**ADDENDUM NO. 2**

April 19th, 2016

2016 Delaware Elementary School Roof Replacement

Morley and Associates, Inc.  
Architect's Project No. 9778**GENERAL:**

**SK-1 - Roof Insulation Plan**

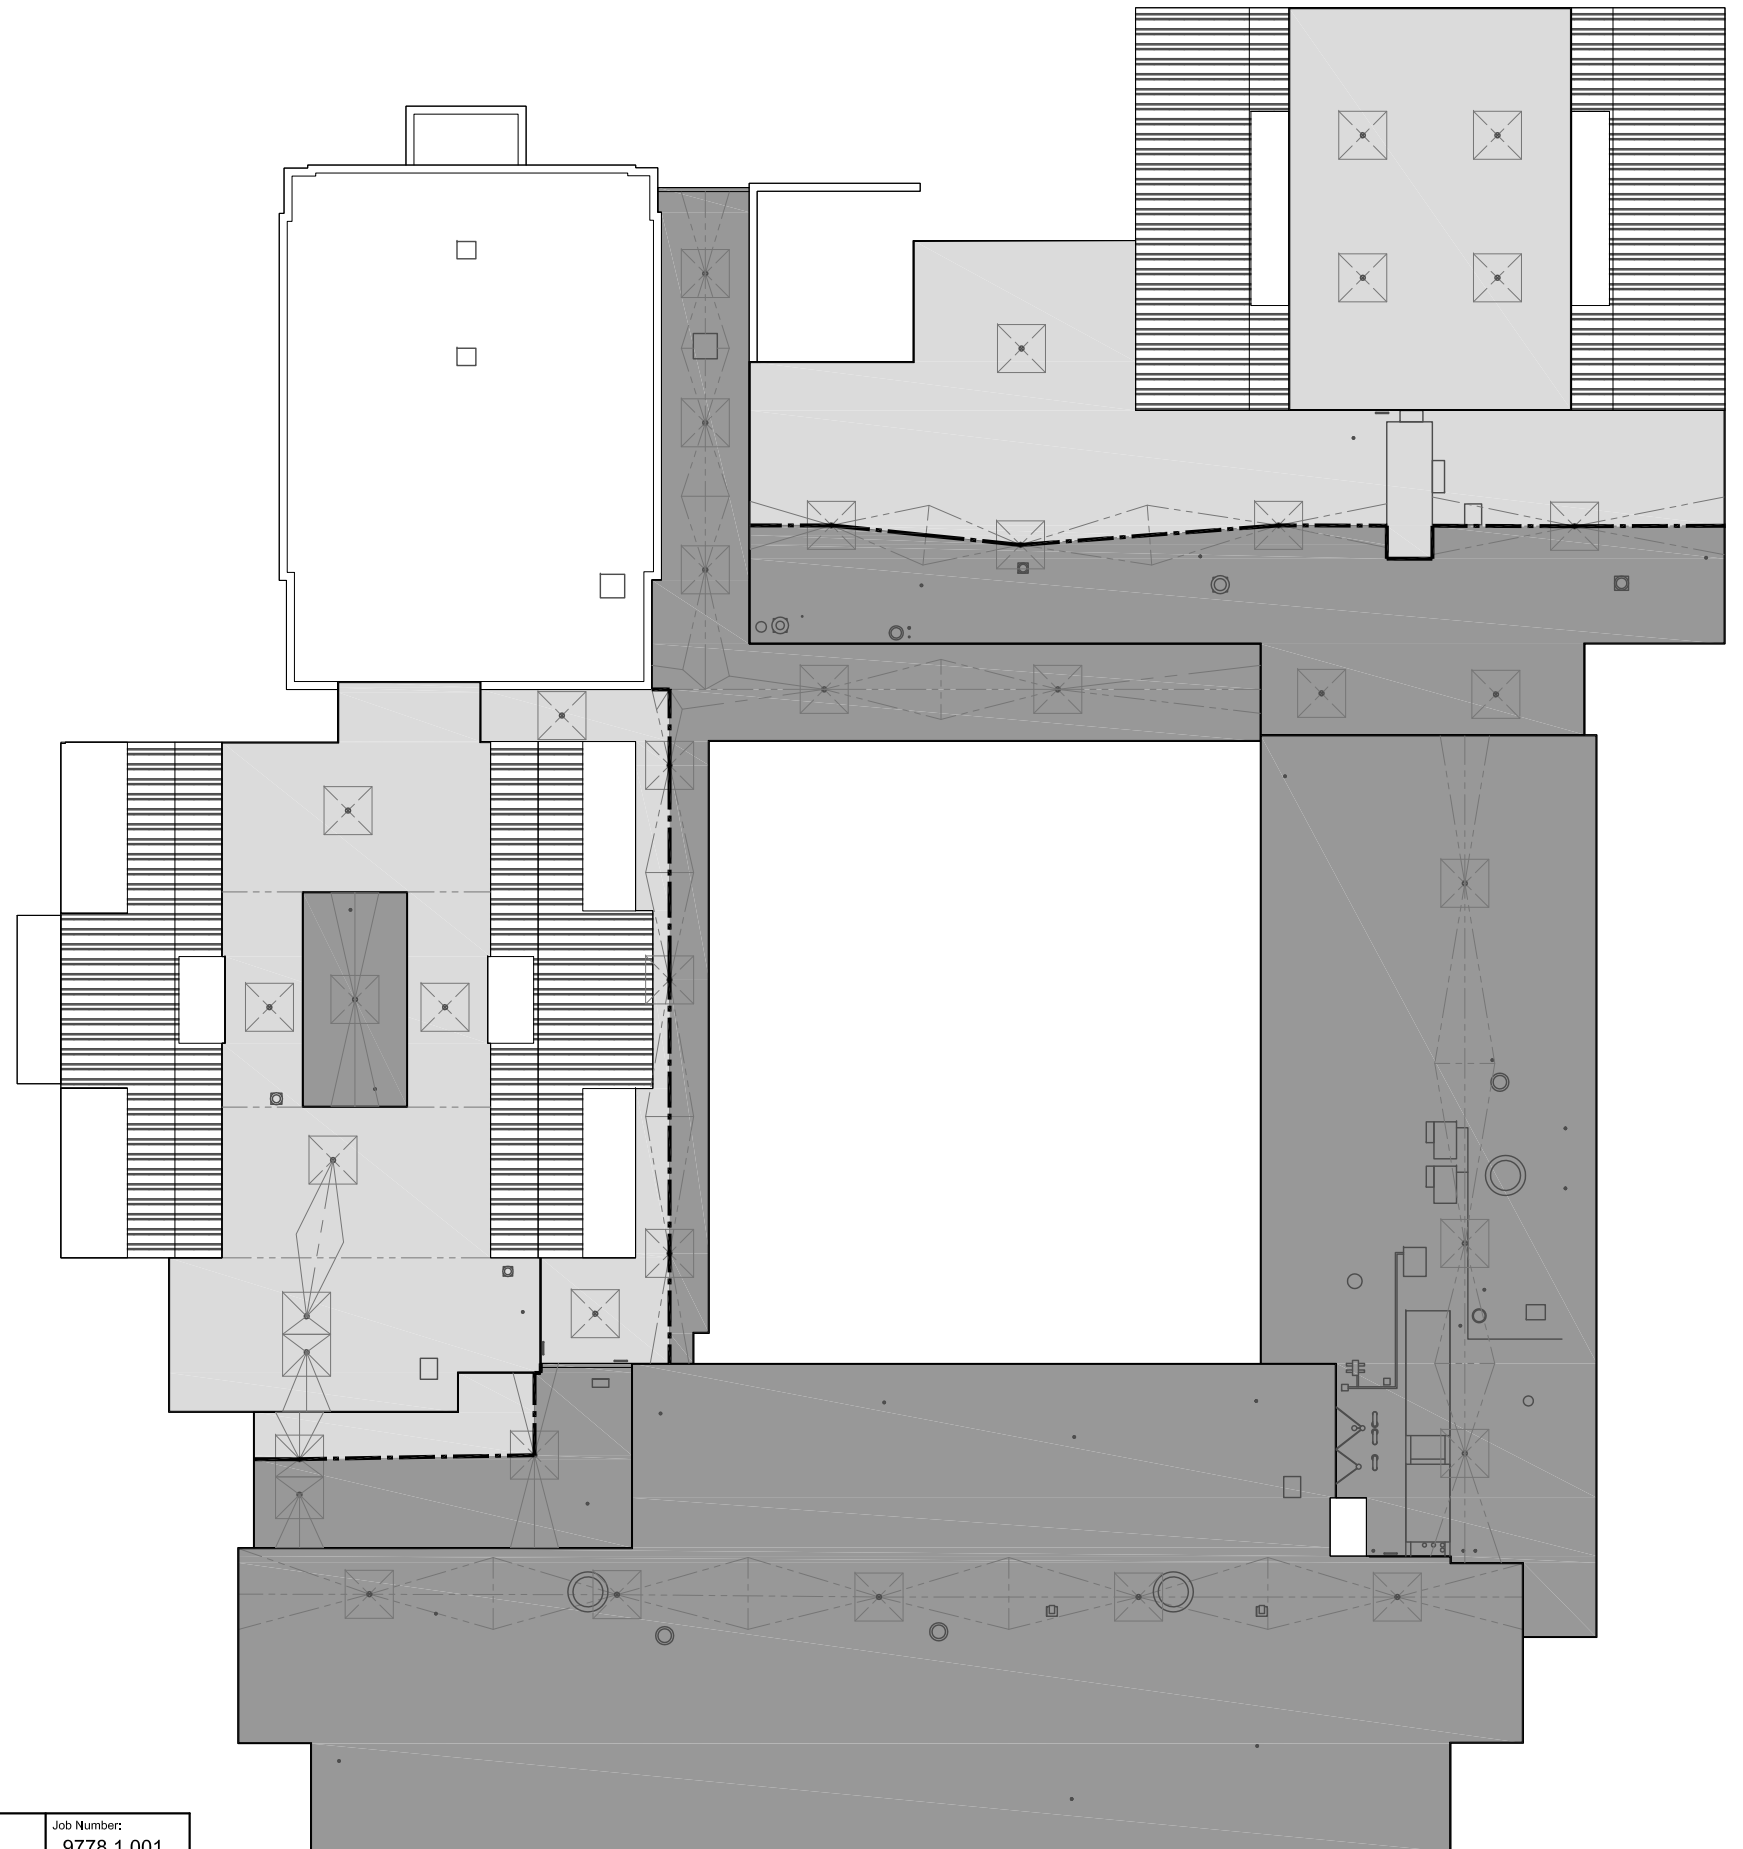
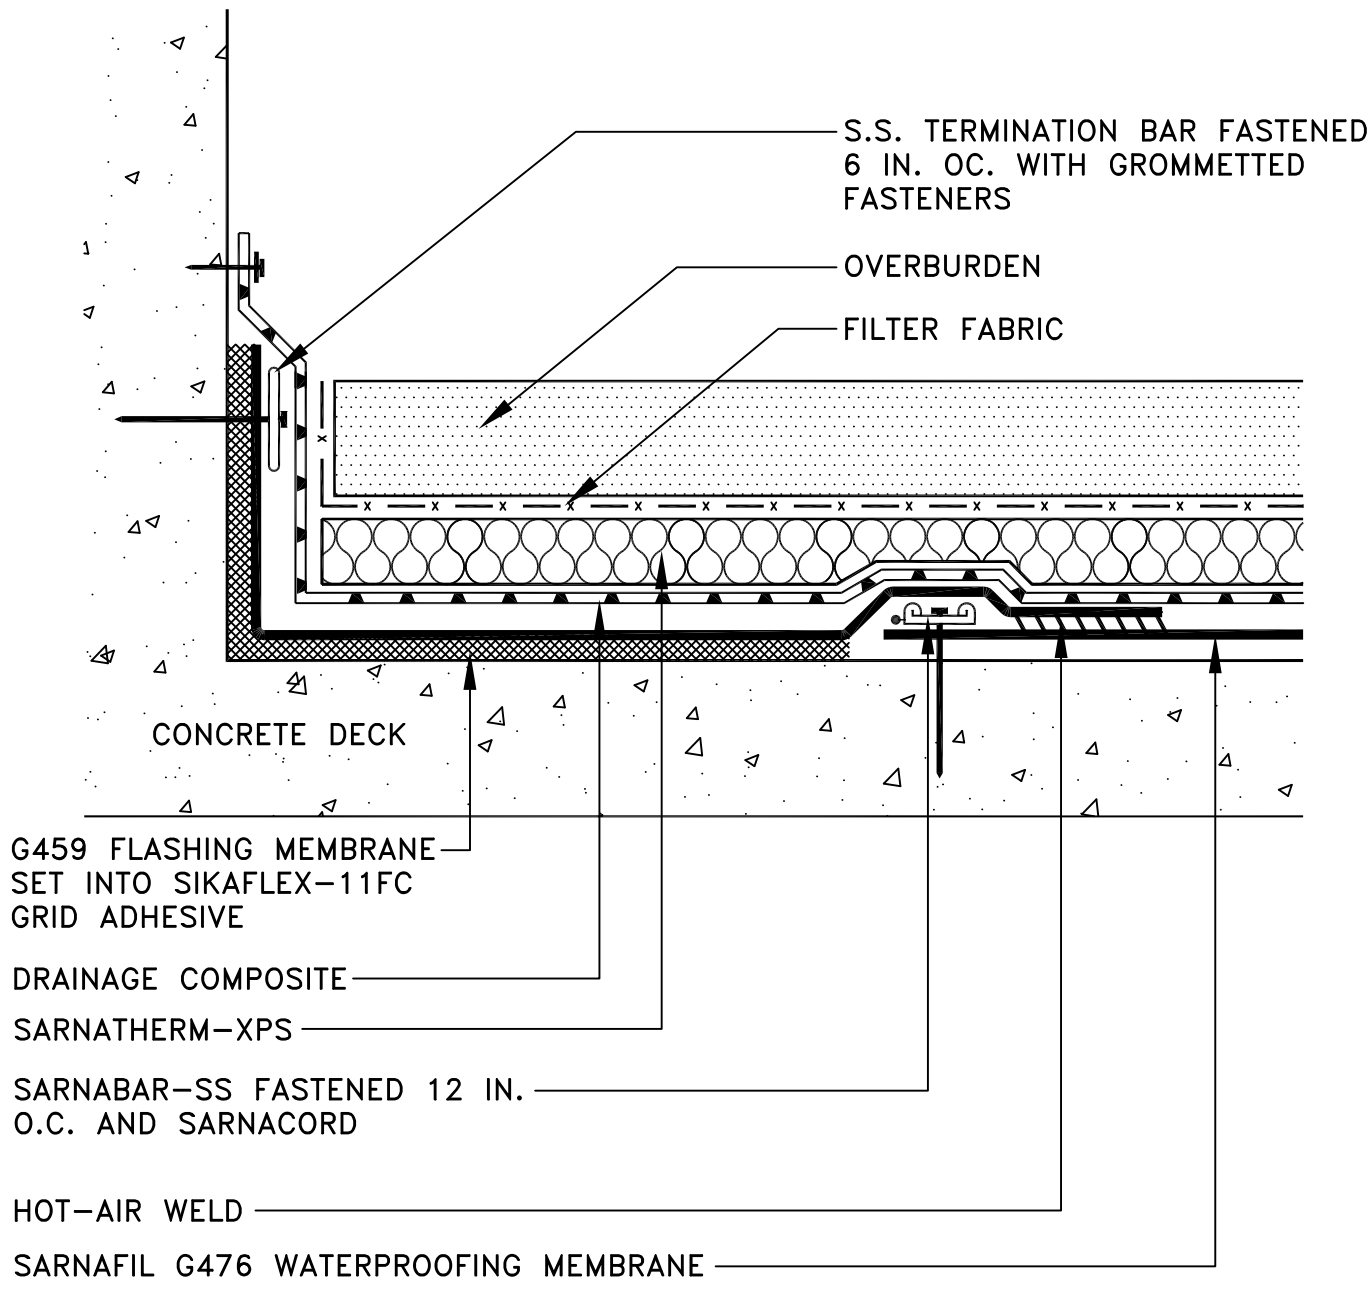
- 2-09 **Architectural:** Clarification of roof insulation thickness and required details when adjacent to skylight flashing, masonry weep holes, and metal wall panel drainage points.

A. Please see SK-1 Roof Insulation Thickness Plan.  
B. Contractor to provide insulation as indicated on SK-1 with low profile flashing details as required to maintain proper drainage of existing construction.

**BELOW GRADE/LOW FLASHING HEIGHT TERMINATION**

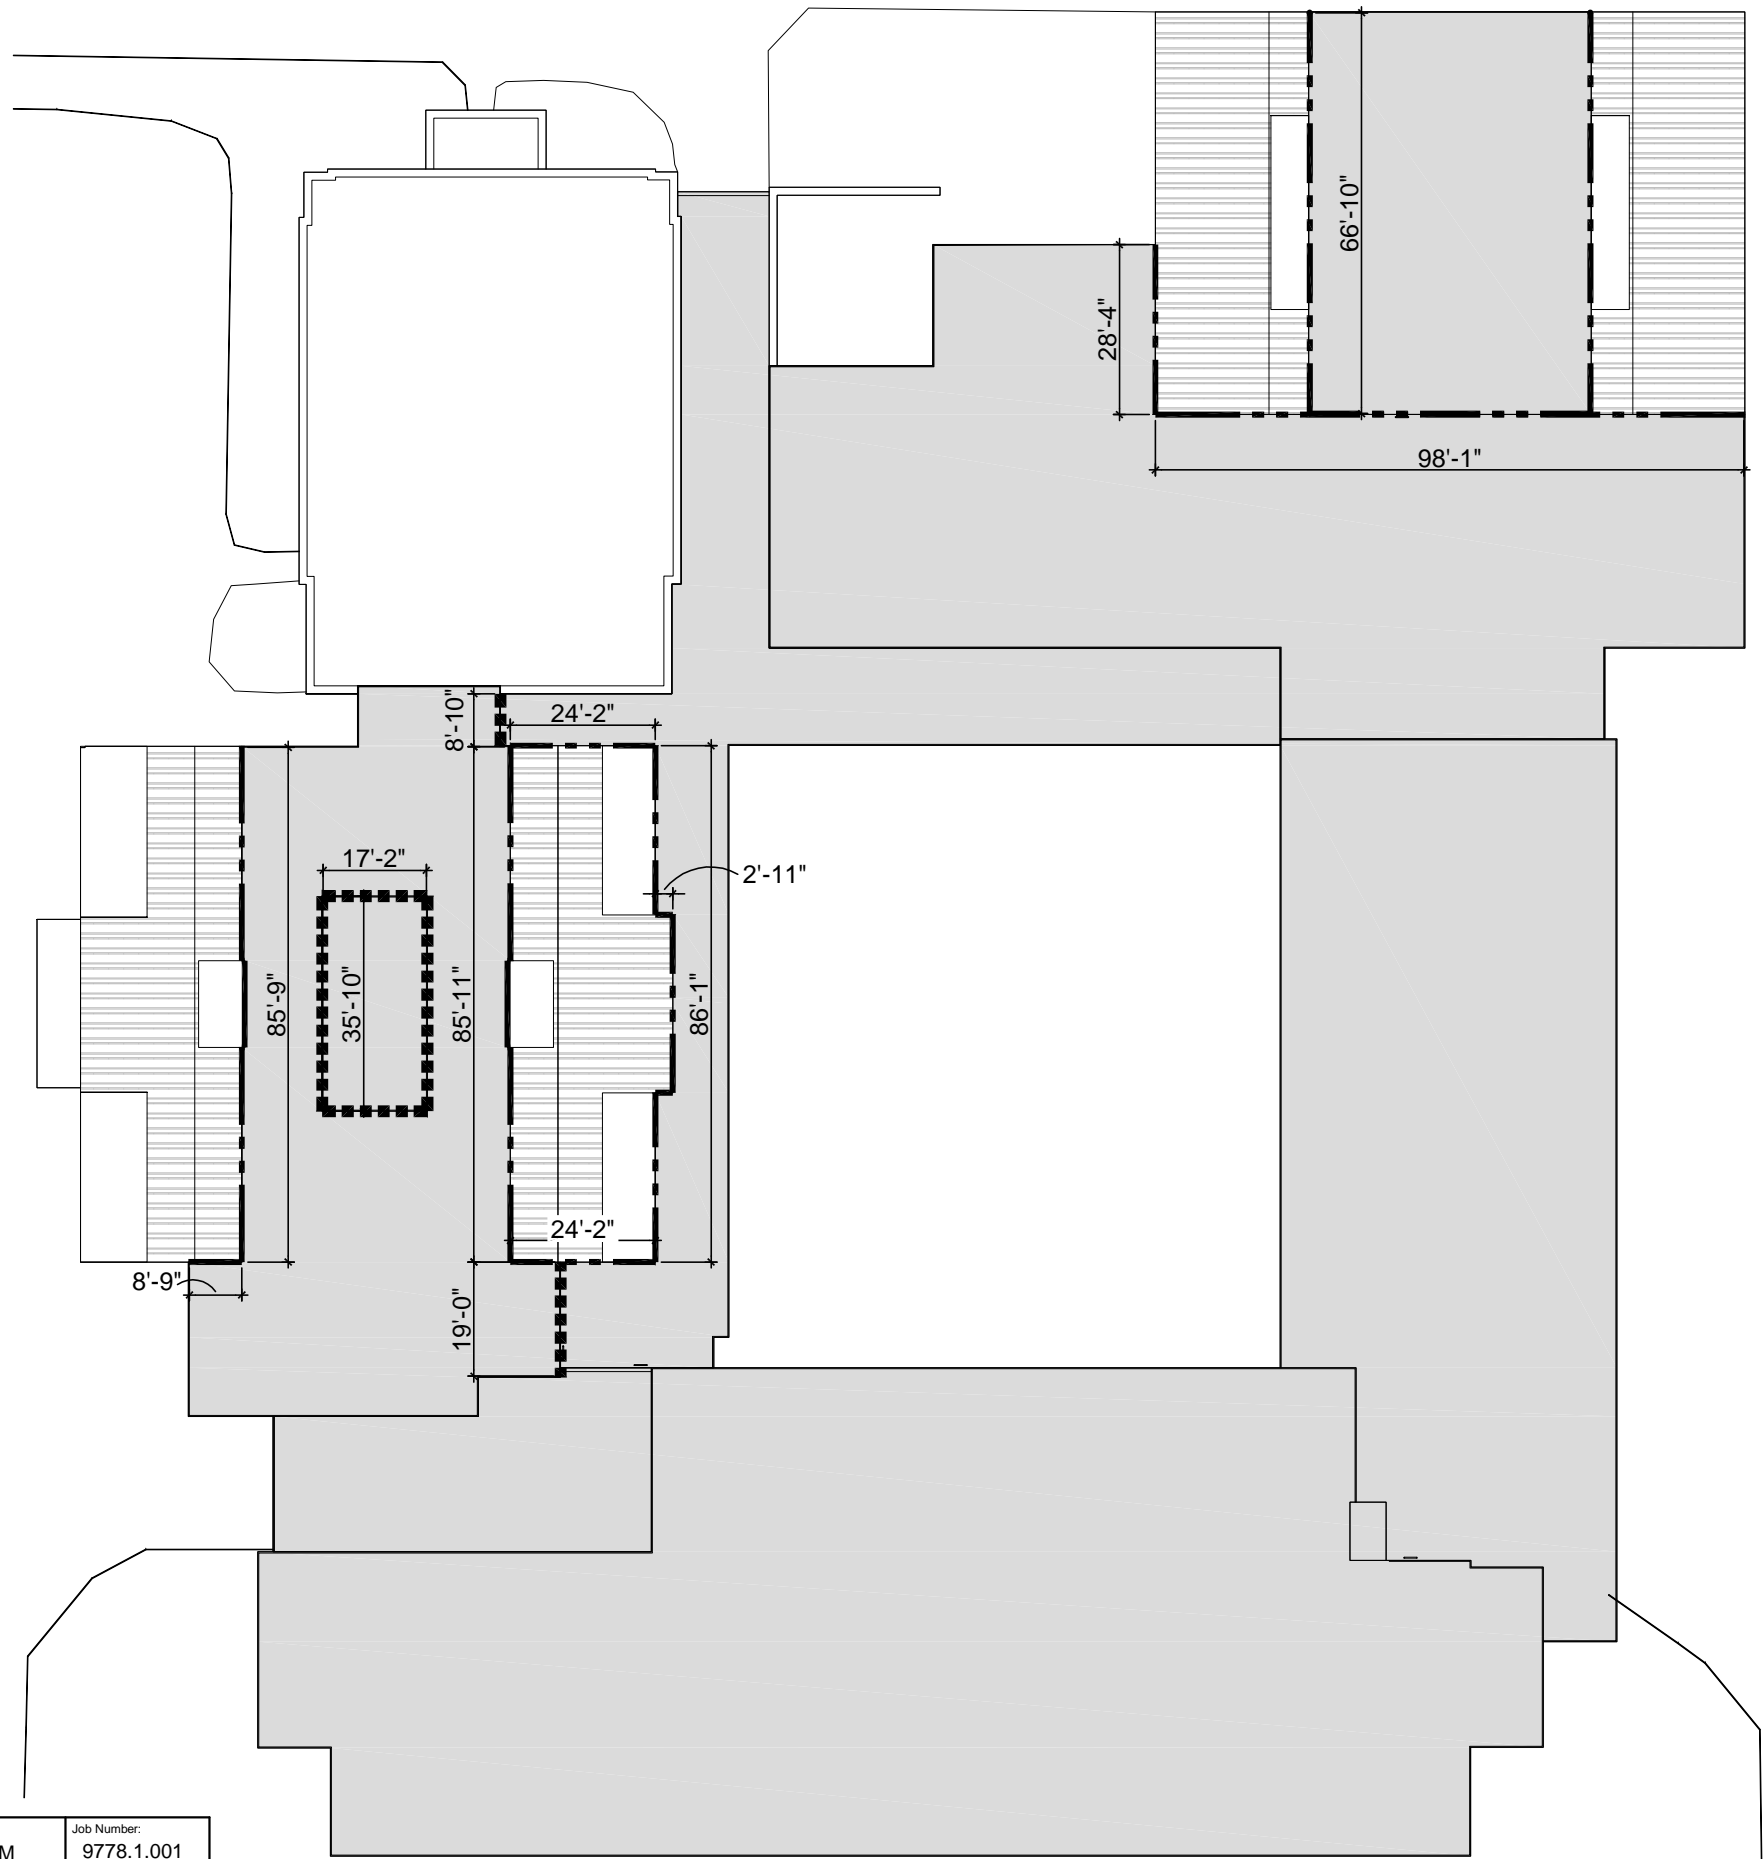
C. Please see attached basis of design details for areas along masonry walls with weep holes, skylights, and metal panels not to be covered.
- 2-10 **Architectural:** Clarification of what composite metal panel walls are to be covered with membrane roofing.

CONTRACTOR TO PROVIDE LOW WALL FLASHING. SEE SARNAFIL "BELOW GRADE/LOW FLASHING HEIGHT TERMINATION" DETAILS AS BASIS OF DESIGN. FINAL DETAILING TO MATCH SELECTED ROOF MANUFACTURER'S WRITTEN RECOMMENDATIONS.
